**SUBMITTAL TO THE BOARD OF SUPERVISORS  
COUNTY OF RIVERSIDE, STATE OF CALIFORNIA**

**SUBJECT:** Adopt Resolution No. 2015-025 Revising the Special Flood Hazard Areas in the Public Flood Hazard Determination Interactive Map Pursuant to Ordinance No. 458; CEQA Finding of Exemption; District 3

4 A RESOLUTION OF THE BOARD OF SUPERVISORS OF THE COUNTY OF RIVERSIDE  
5 REVISING SPECIAL FLOOD HAZARD AREAS IN THE PUBLIC FLOOD HAZARD  
6 DETERMINATION INTERACTIVE MAP PURSUANT TO ORDINANCE NO. 458

#### **DETAILS IN SUPPORT OF REVISING THE SPECIAL FLOOD HAZARD AREA IN THE PUBLIC FLOOD HAZARD DETERMINATION INTERACTIVE MAP PURSUANT TO ORDINANCE NO. 458**

**EXHIBIT A**

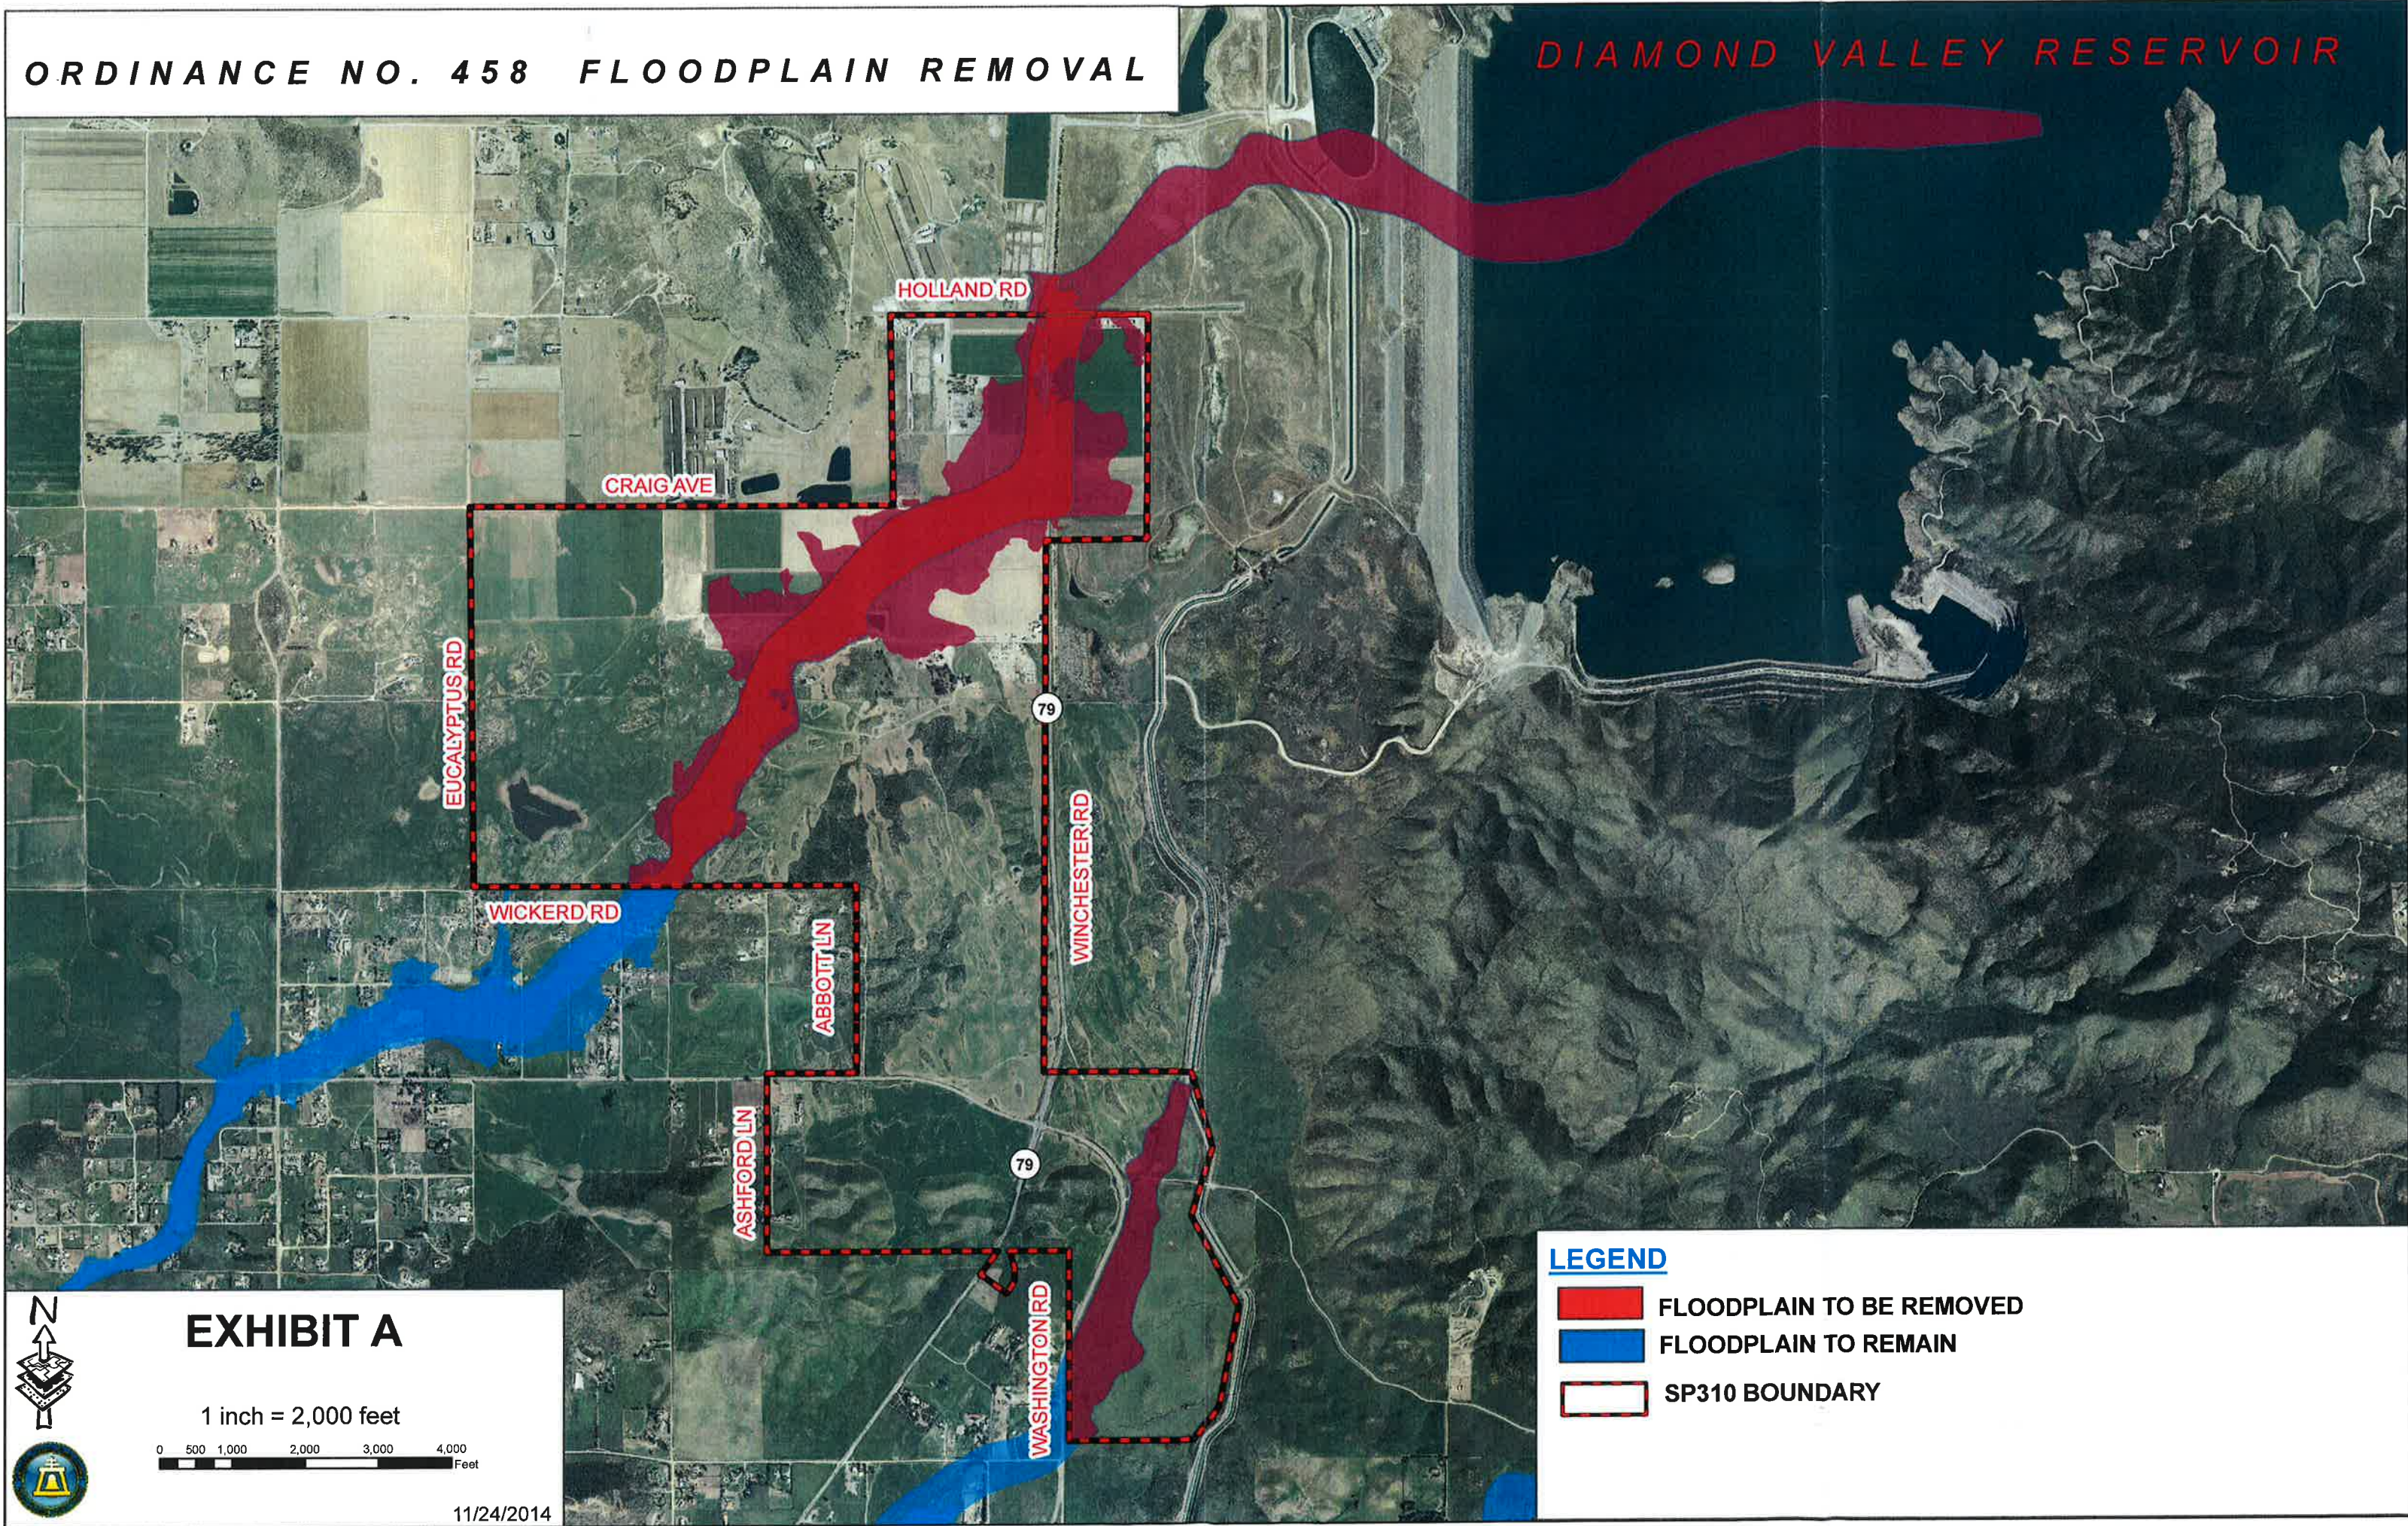
1 the Interactive Map; and that the Special Flood Hazard Area shown in red on Exhibit "A" is in error and  
2 recommends such area should be deleted from the Public Flood Hazard Determination Interactive Map;

- 15 3. Revising the Special Flood Hazard Areas in the Public Flood Hazard Determination  
16 Interactive Map is hereby authorized and the floodplain limits shown in red on attached  
17 Exhibit "A" shall be deleted.

Therefore, the special flood Hazard Areas along Warm Springs Creek and the unnamed tributary shown in red on the attached exhibit shall be revised and removed from the Public Flood Hazard Determination Interactive Map.

The attached exhibit, SP310 Floodplain Removal shows the limits of the current floodplain and the portions to be removed. The unnamed tributary floodplain shown on the southern portion of the exhibit should be deleted upstream (east) of Washington Road deleted. The Warm Springs Creek floodplain shown on the northern portion of the exhibit should be deleted upstream (north) of Wickerd Road removed.
